UNITED STATES PATENT AND TRADEMARK OFFICE

APPLICATION NO.	FILING DATE	FIRST NAMED INVENTOR	ATTORNEY DOCKET NO.	CONFIRMATION NO.
10/604,078	06/25/2003	Rodney A. Kendall	FIS920030065	1077

Office Action Summary	Application No.	Applicant(s)	
	10/604,078	KENDALL ET AL.	
	Examiner	Art Unit	
	Victor MacArthur	3679

DETAILED ACTION

Figure 2

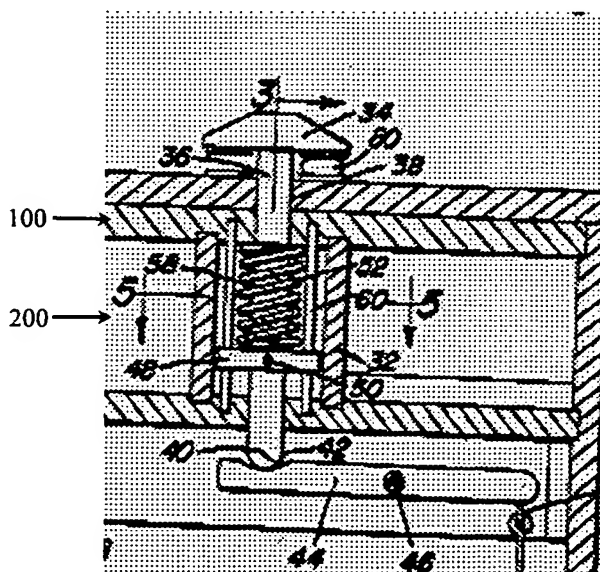
Claims 1-6 are rejected under 35 U.S.C. 102(b) as being anticipated by Prescott (U.S.

Patent 2,712,769) (see marked-up drawing below).

Claim 1. Prescott discloses (fig.2) an apparatus for clamping a reference surface (surface of 24 contacting 100) of an object (80, 24) to a reference surface (surface of 100 contacting 24) of a support member (100), comprising: at least one clamping member (200 of the marked-up figure above denotes a clamping member in as much as 100 of the applicant's drawings does) having means (52) for applying compressive force between a first contact surface (surface of 52 contacting 100) and a second contact surface (surface of 34 contacting 80), said first contact surface being in contact with a support surface (surface of 100 contacting 52) of said support member, said support surface of said support member being opposite said reference surface of said support member, each of said clamping members having a base member (34) with a contact area (area of 34 contacting 80) in contact with a support surface (surface of 80 contacting 34) of said object (80, 24), said support surface of said object being opposite said reference surface of said object, each of said clamping members having a tension member (36) passing through holes (hole in 100, hole in 24) in said support member and said object for applying a force to said base member and for supporting said object when said force is released, said tension member being adapted to maintain a tensile force (within itself between 48 and 34) and having a cross section adapted such that said tension member exerts transverse force (force applied to 80 is in a transverse direction with respect to 24) on said object less than a threshold amount (some amount greater than that supplied by 52, which might damage 80) in response to transverse displacements of said clamping member such that the deviation from an adjusted position is within a relevant error budget (any relevant error budget).

Claim 2. Prescott discloses that the means for applying compressive force is a spring (52) and said first contact surface is a surface of said spring.

Claim 3. Prescott discloses release means (44) for releasing compressive force.

Claim 4. Prescott discloses that the release means comprises a lever pressing (indirectly via 36 and 48) against the means for applying compressive force. Note that the lever (20) of the applicant's invention does not directly contact the spring (120).

Claims 5 and 6. Prescott discloses that support means (portion of 100 contacting 24) support the object when the compressive force is released.
